**Amendments to the
Cascade Station/Portland
International Center Plan District**
Amendments to Title 33, Planning and Zoning

Ordinance No. 179076
Adopted February 17, 2005

Amendments to Chapter 33.508, Cascade Station (CS)/Portland International Center (PIC) Plan District and New Section 33.807, CS/PIC Transportation Impact Analysis

Figure 508-1
Park Blocks and Build-To-Line Area

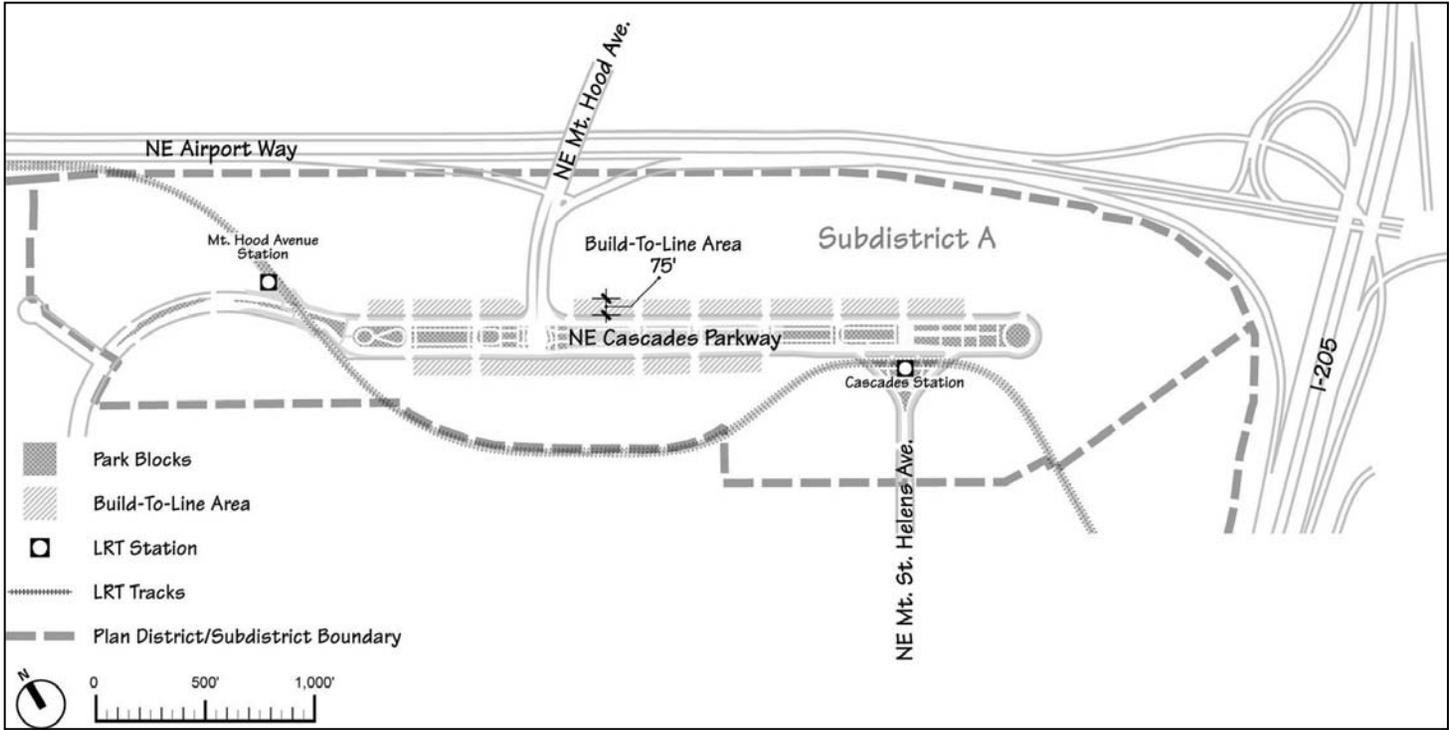
Figure 508-1 is replaced with a new figure with the following changes:

- Expand to include all of Subdistrict A
- Revise the Build-to-Line Area (BLTA) to remove it from the "U shaped" eastern end
- Change depth of BTLA area to match depth referenced in text (75'),
- Remove the former "triangle lot areas" so they no longer need a special exemption
- Base the illustration on the Park Blocks as they were actually constructed
- Improve and standardize the features of the illustration with other Title 33 figures.

Replace Figure 508-1 with updated Figure 508-1 shown below

Figure 508-2
Build-To-Line Setback Illustration

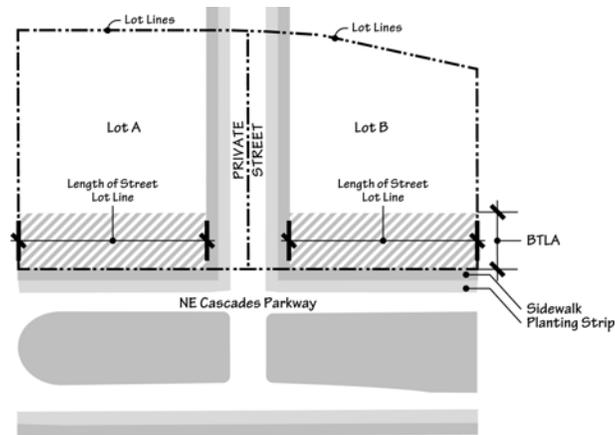
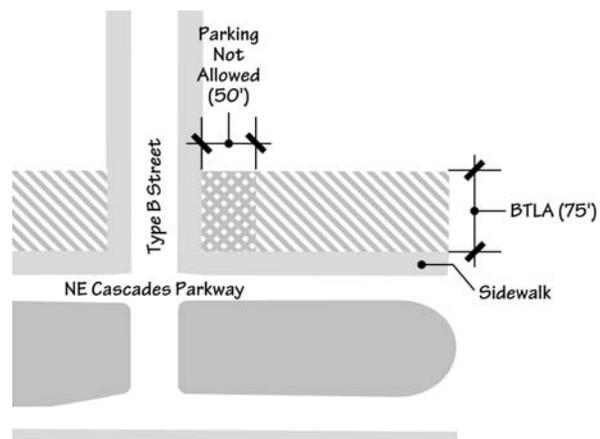
The developers requested reconsideration of the setback standard as requiring buildings on all corner lots constrains desired design flexibility and presents problems in creating a varied and interesting pedestrian environment. The new language for 230.D.1.c (3) and (4) provides some flexibility because where a lot fronts on both Cascades Parkway and a Type A, C, or D street, the buildings must come up to both frontages. However, where a lot fronts on both Cascades Parkway and a Type B street, the maximum setback only applies along Cascades; the side street is exempt. A new figure 508-3 illustrates this concept.

A clarified figure 508-2 and new illustrative figure 508-3 correspond to new setback language for the Build-to-Line area provision.

- (4) Exception. Buildings with street lot line frontage on both NE Cascades Parkway and a Type B street must meet the standards of D.1.c.(1) and (2) on the NE Cascades Parkway street lot line frontage, but do not have to meet the standards on the Type B street lot line frontage. However, surface parking is not allowed within 50 feet of the street lot line frontage on the Type B street within the BTLA. See Figure 508-3.

**Figure 508-34
Building Entrances**

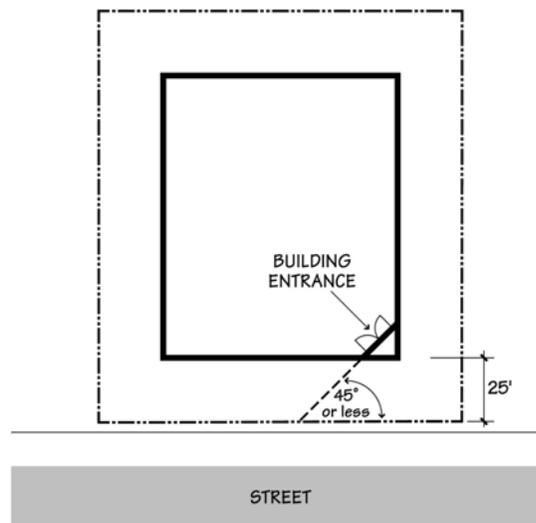
Figure 508-3 replaced with updated Figure 508-4 below

(2) Be at an angle of up to 45 degrees from the street lot line street, measured from the street lot line, as shown in Figure 508-4; or

Figure 508-5
Cascades Station Area

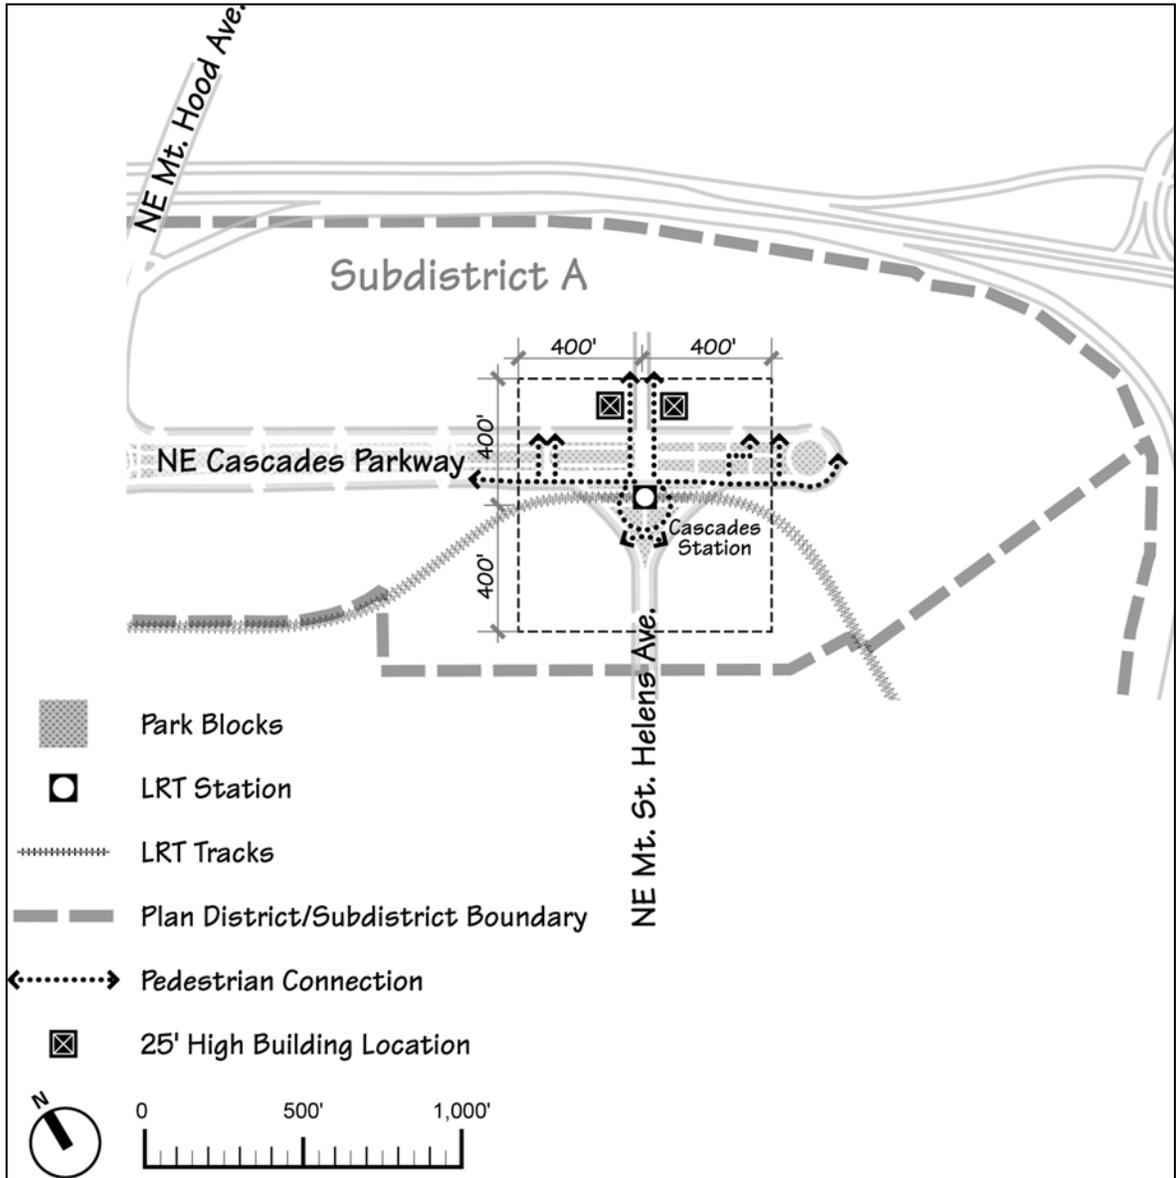
Figure 508-2 replaced with updated Figure 508-5 below

E. **Within Cascades Station Area.** All development within the ~~East Cascades~~ Station Area, shown on Figure 508-5, must meet the regulations of this Subsection.

Figure 508-6
Mt. Hood Station Area

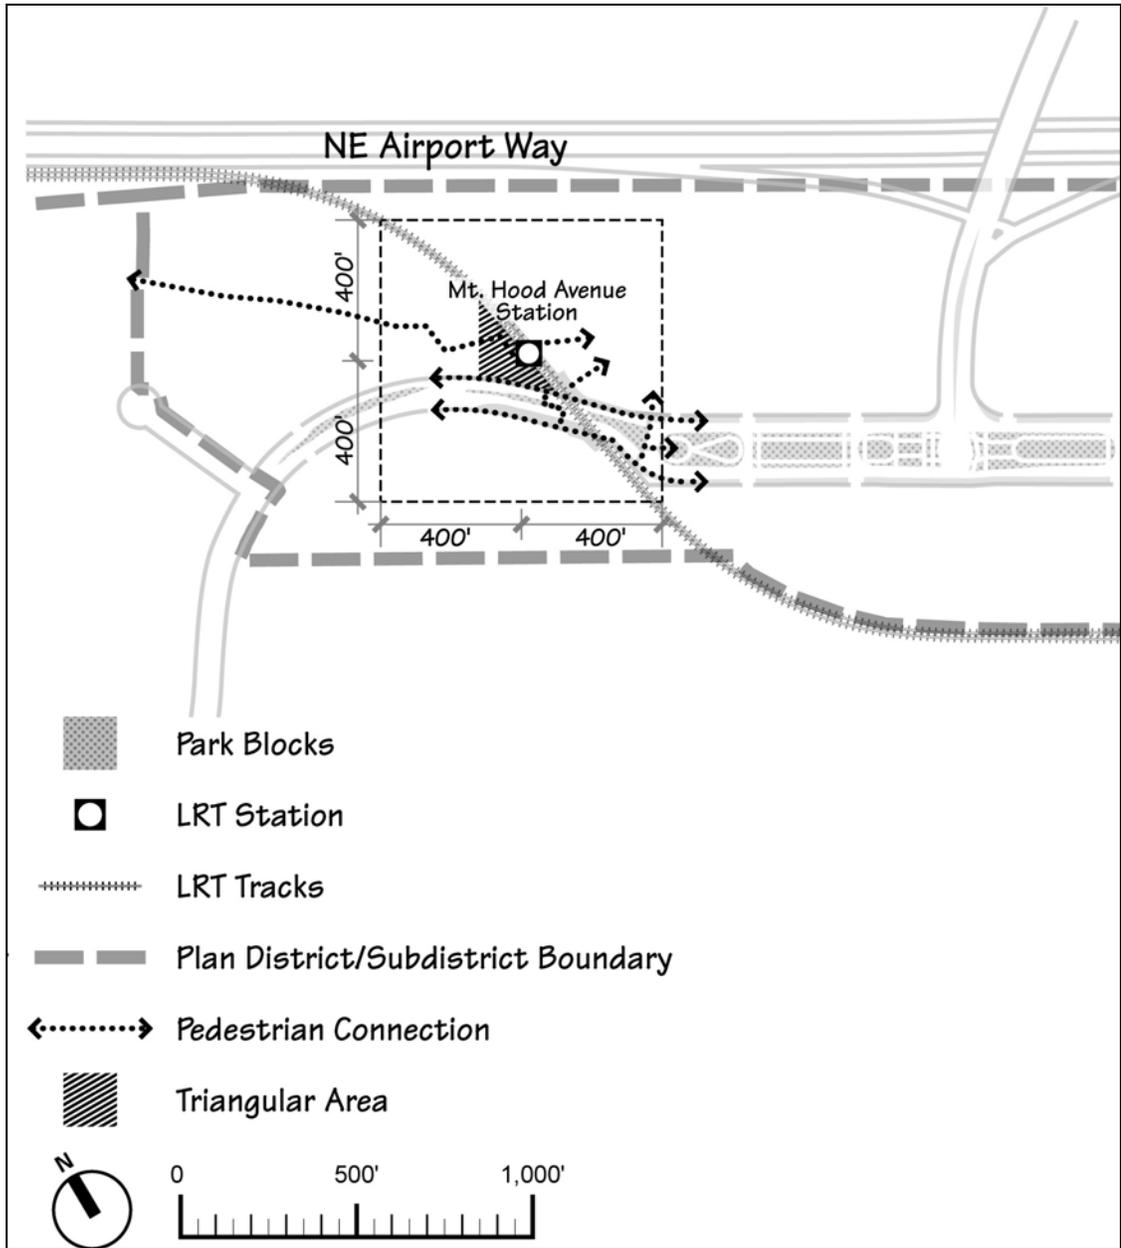
Given the emphasis on station areas in lieu of emphasizing the entire BTLA, this section is added to create standards for the Mt. Hood Station Area that parallel those that apply to the Cascades Station Area. There is a new Figure 508-6 that shows the area included under this provision. These standards are supplemented by provisions for master planning and design elements in the PDC Development Agreement.

New Figure 508-6

F. Within Mt. Hood Station Area. All development within the Mt. Hood Station Area, shown on Figure 508-6, must meet the regulations of this Subsection.

2. Pedestrian connections. Pedestrian connections from the light rail platform must provide for pedestrian movements to the Park Block pedestrian network, to the lots to the south across NE Cascades Parkway. The connections must be in the general location shown on Figure 508-6.

Figure 508-7
Basic Public Infrastructure

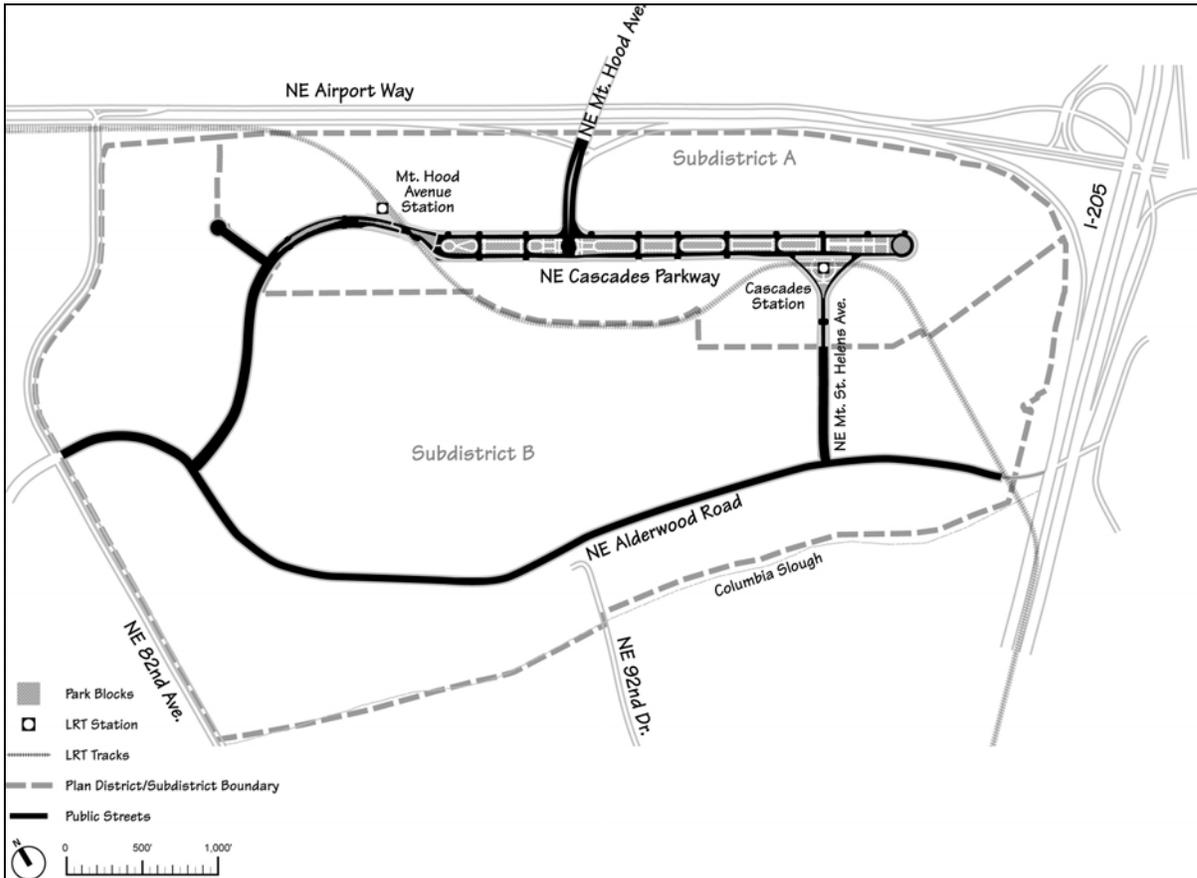
The infrastructure required by this section has already been constructed and the section is recommended for deletion. The existing Figure 508-4 is replaced with a new Figure 508-7.

Replace Figure 508-4 with Figure 508-7 below that does not include East-West "loop street" and two public streets north of NE Cascades Parkway, and move figure to subsection 33.508.280.A

A. Public streets. Public streets are shown on Figure 508-7. Some of these streets have been completed and dedicated.

Figure 508-8
Street Requirements in Subdistrict A

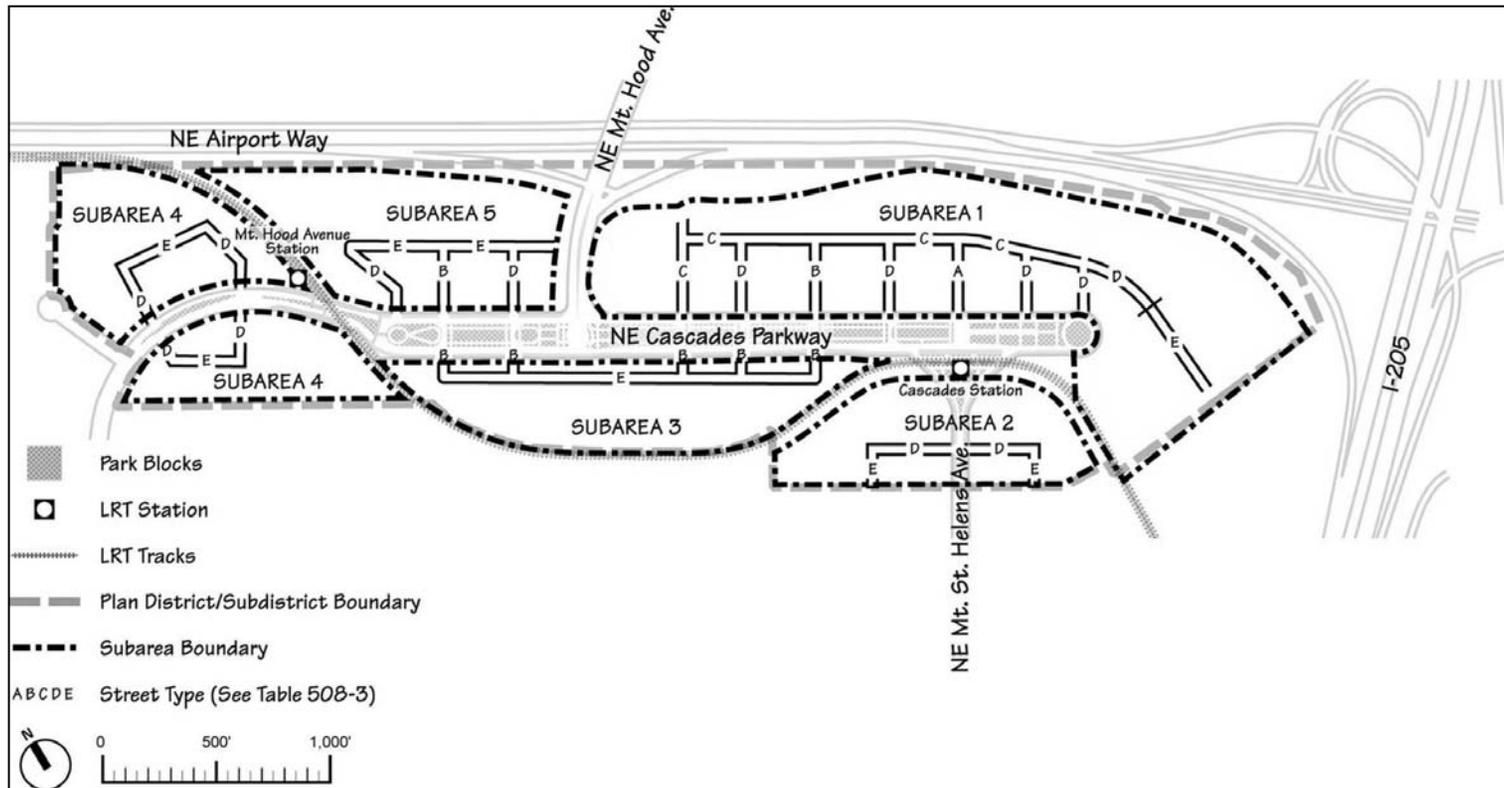
The Street Requirements in Subdistrict A (Figure 508-8) will be used and enforced by BDS and PDOT and also used by the Coordinated Design Review process, as the subareas match up with the required master planning subareas.

Figure 508-5 replaced with updated Figure 508-8 Street Plan shown below

- a. The approximate locations for private streets are shown in the Street Plan, Figure 508-8.
- b. The Portland Office of Transportation and BDS determine the extent and timing of street improvements.
- c. Buildings and other improvements must be located so that they do not preclude creation of streets in conformance with the Section.
- d. All measurements in the Section are from centerline to centerline, unless specified otherwise.

**Figure 508-9
Type A Street**

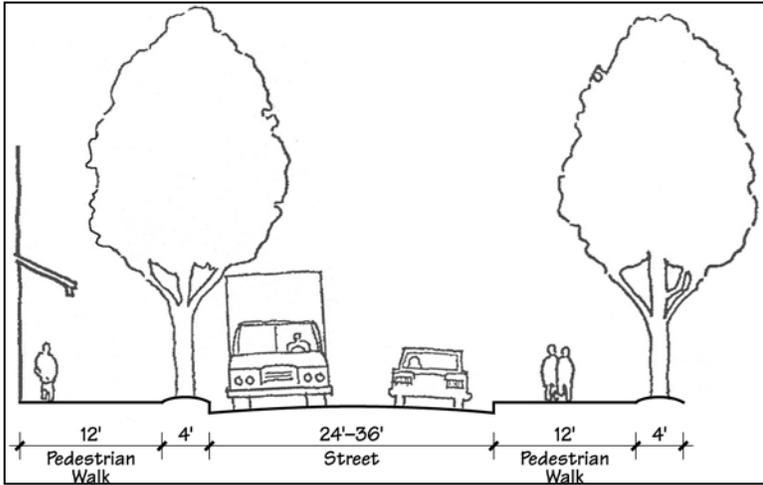
Illustration Figures 508-7 and 508-8 are deleted and replaced with new figures 508-9 and 508-10 as part of the street requirements described in this section and new Figure 508-8 and Table 508-3.

Figure 508-6 replaced with new Figure 508-9 shown below

**Figure 508-10
Type B Street**

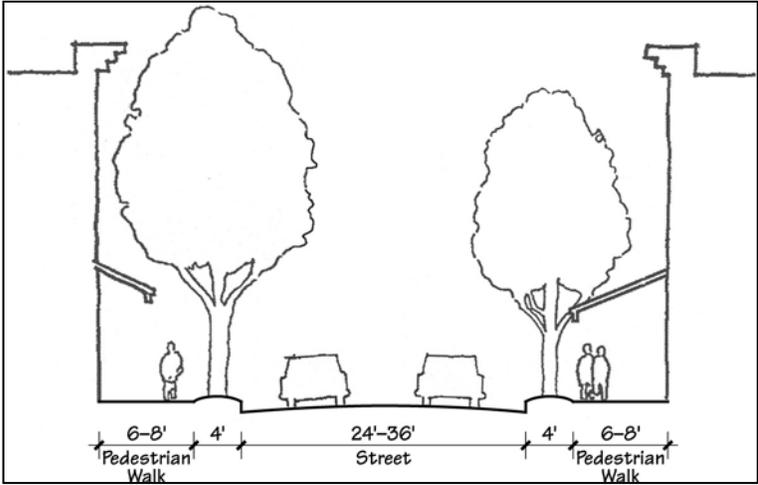
Figure 508-7 replaced with new Figure 508-10 shown below

Figure 508-11
Type C Street

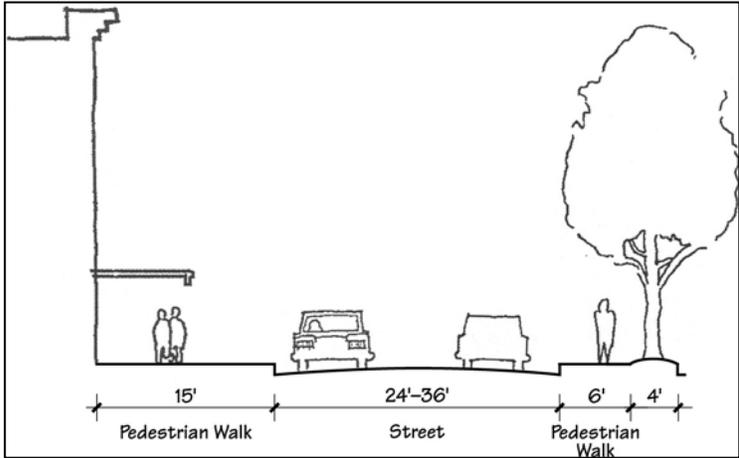
New illustrative Figures 508-11 and 508-12 are added as described in this section and new Figure 508-8 and Table 508-3.

New Figure 508-11 shown below

Figure 508-12
Type D Street

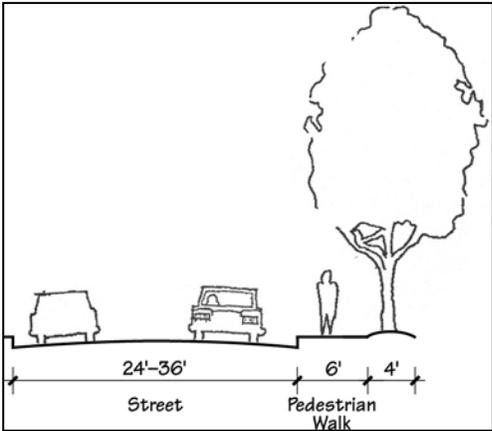
New Figure 508-12 shown below

Figure 508-09~~13~~
Bicycle and Pedestrian Circulation Plan

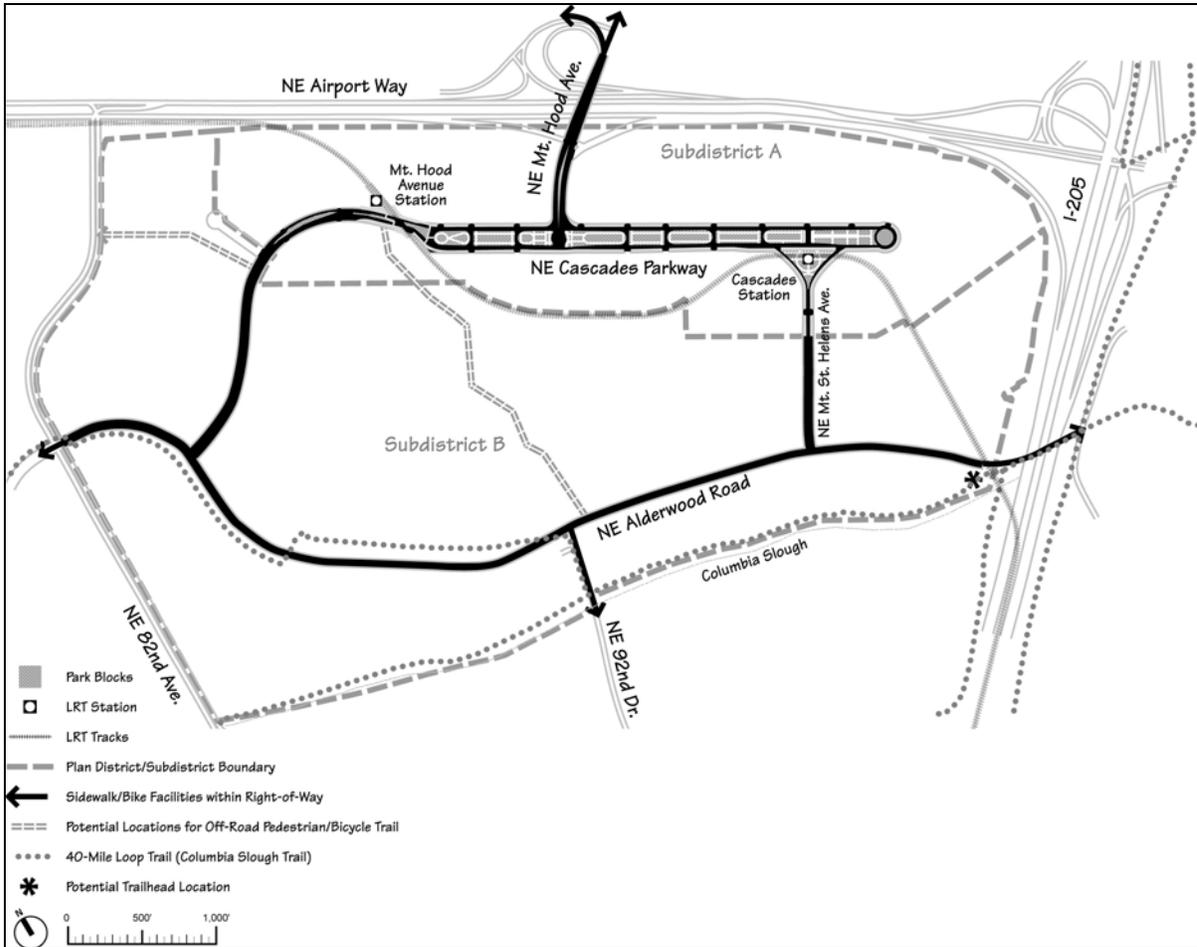
It is appropriate for the proposed trail connection from the south to the Mount Hood Station Area as depicted in Figure 508-13 be built when the area south of the station area develops.

Figure 508-09 replaced with updated Figure 508-13 shown below
